ADMINISTRATIVE AMENDMENT

COUNTRY CLUB PLAZA I
1716 CENTRAL AVE., SW
ALBUQUERQUE, NM 87104

OVERALL SITE PLAN-
FOR ADMINISTRATIVE
AMENDMENT

SITE PLAN
AMENITIES PLAN AND
ELEVATIONS

Architectural Site Plan
Scale: 1"=30'-0"

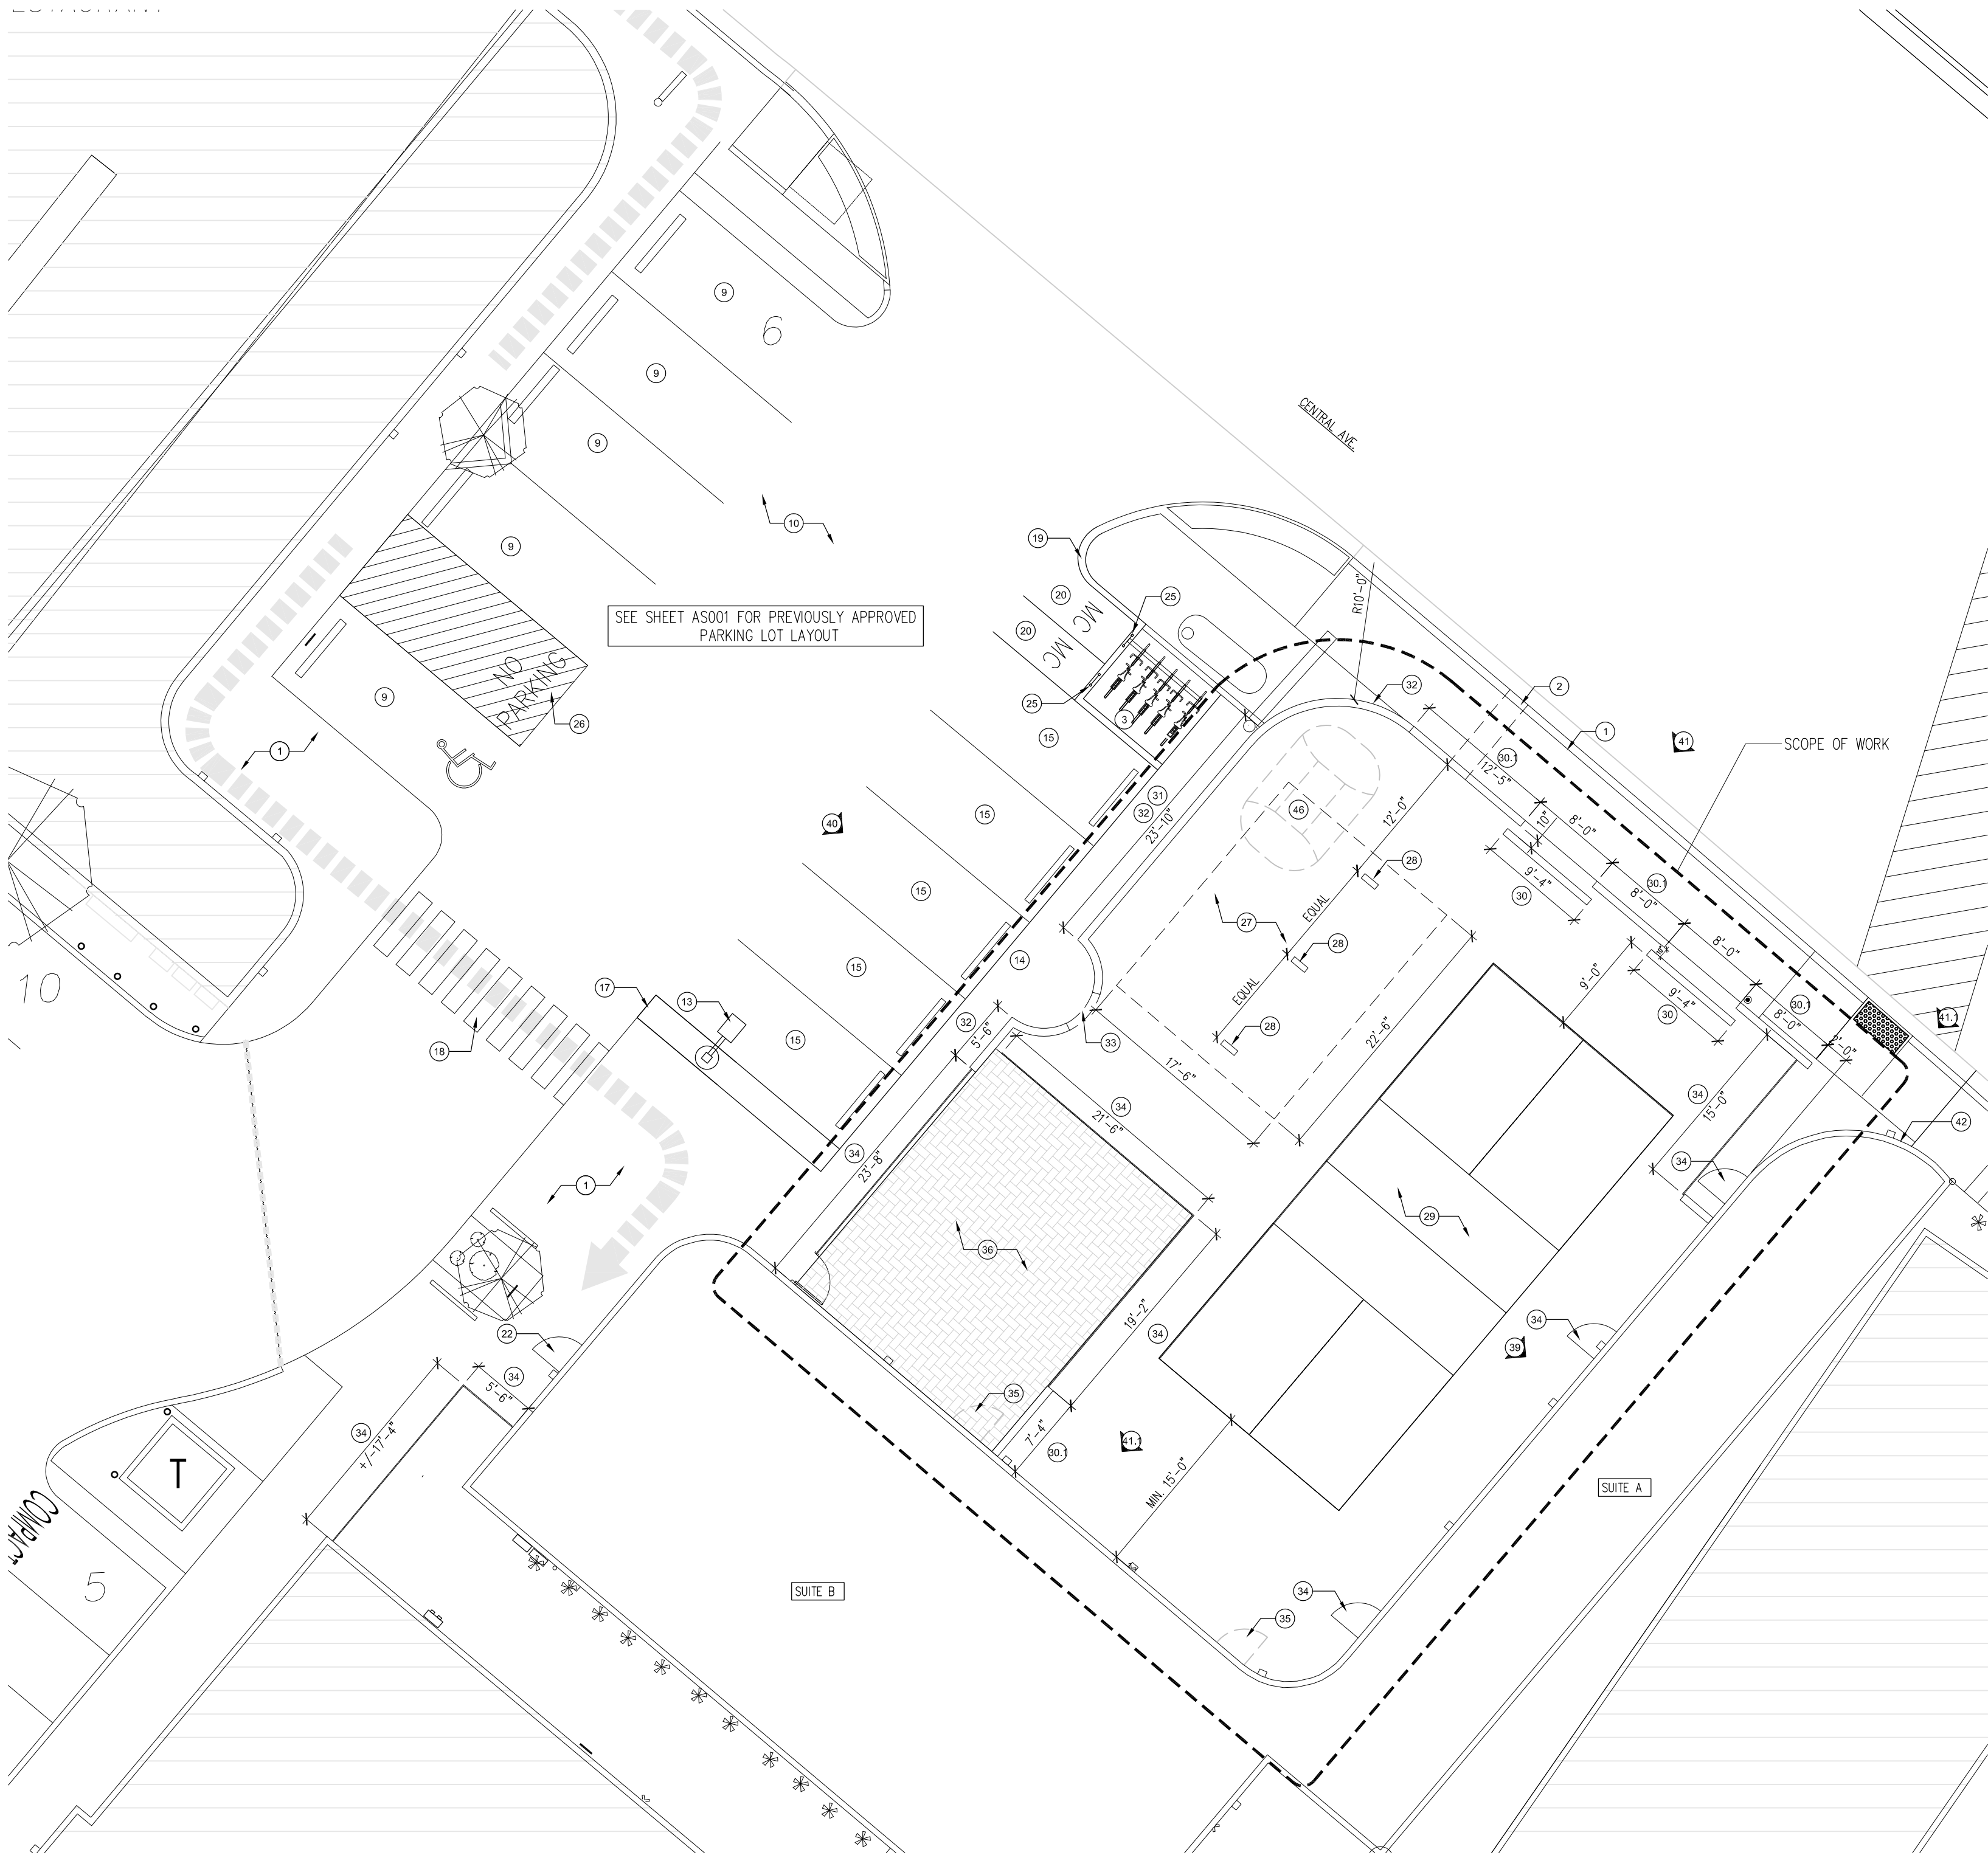
- THE PURPOSE OF THIS ADMINISTRATIVE AMENDMENT IS TO MAKE REVISIONS TO THE EXISTING PARKING LOT LOCATED AT THE NORTH WEST CORNER OF THE PROPERTY, SAID CHANGES INCLUDE THE FOLLOWING:
 - REVISE PARKING LAYOUT - ELIMINATE 4 STANDARD PARKING SPACES - RELOCATE 5.
 - REALLOCATE PARKING AREA AS USABLE OPEN SPACE
 - RELOCATE EXISTING PARKING LOT PEDESTRIAN CROSSING
- CHANGES TO SITE DEVELOPMENT PLAN DO NOT MEET THE THRESHOLD FOR NEW HEARING - REPRESENT LESS THAN 10% OF OVERALL SITE
- REVISION TO SITE DEVELOPMENT PLAN INCLUDES UPDATES TO THE PARKING CALCULATIONS BASED ON THE CURRENT ADDITION OF THE INTEGRATED DEVELOPMENT ORDINANCE (IDO)

B1 Partial Site Plan-Amenities Court
1"=10'-0"

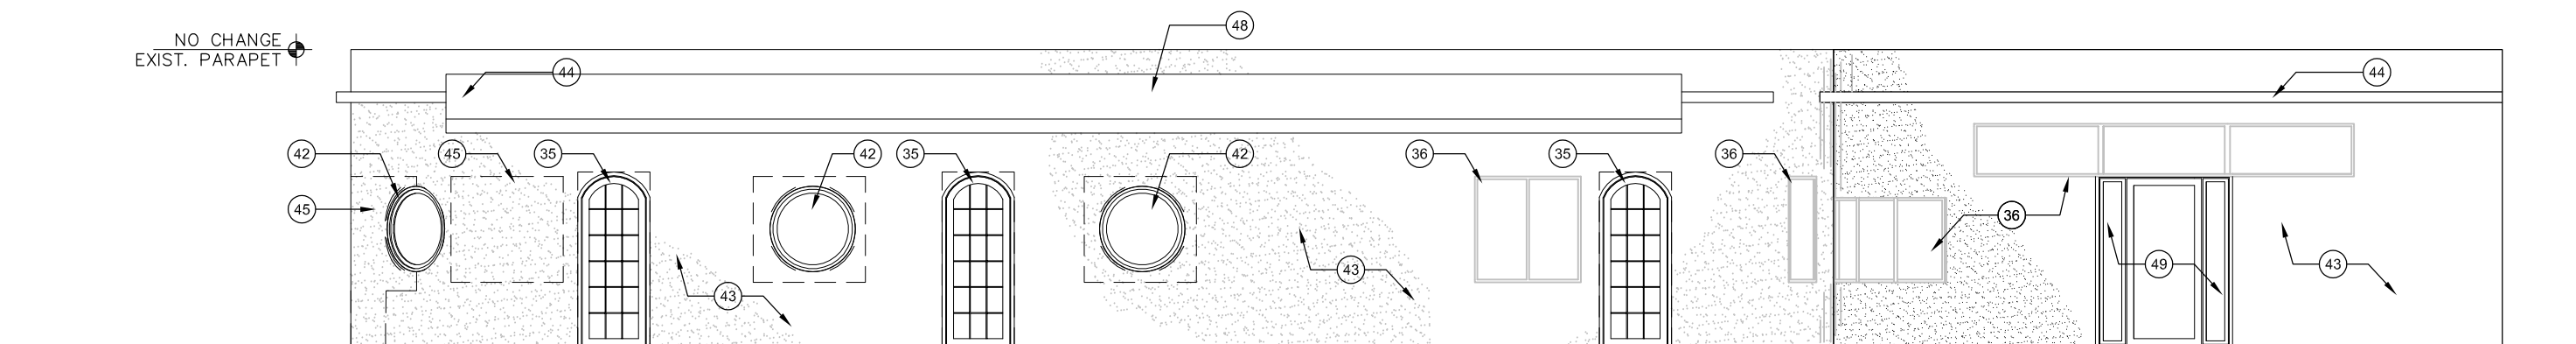
THE PURPOSE OF THIS MINOR AMENDMENT IS TO IMPROVE AMENITIES FOR THE
EXISTING RESTAURANT INCLUDING FACADE CHANGES TO SITE DEVELOPMENT.
CHANGES INCLUDE THE FOLLOWING:
- REPLACEMENT OF SQUARE WINDOWS WITH ROUND WINDOWS, RECTANGULAR
DOORS WITH ARCHED DOORS.
- THE ADDITION OF SITE WALLS TO PROVIDE SECURITY TO THE NEW
RESTAURANT.
- ADDITION OF 42" SLAT WALLS TO DEFINE SERVICE AREAS FOR OUTDOOR
SEATING
- THE ADDITION OF A NEW SHADE STRUCTURE
